County of San Diego
Planning & Development Services
BUILDING DIVISION

ACCESSIBILITY CORRECTION LIST

Multifamily Housing

Drinking Fountains

CBC FIGURE 11A-1H(b) – ALCOVE MANEUVERING SPACE

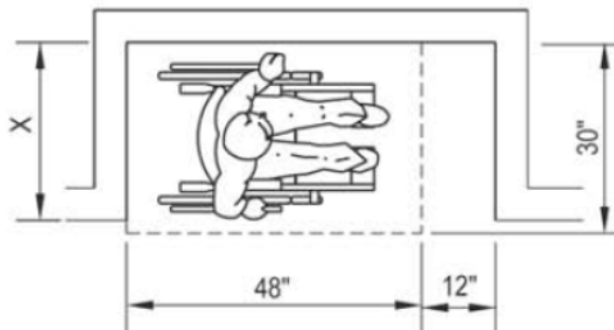
4. Dimension minimum 32-inch-wide by 18-inch-deep drinking fountain alcoves per CBC Figure 11A-11A(a).
Exception: Minimum 32-inch-wide by 18-inch-deep wing walls per CBC Figure 11A-11A(b) acceptable if extending to within 6 inches of floor
Exception: Additional width required at alcoves or wing walls with depth greater than 24 inches per CBC Figure 11A-1H(b)
CBC 1139A.3.1
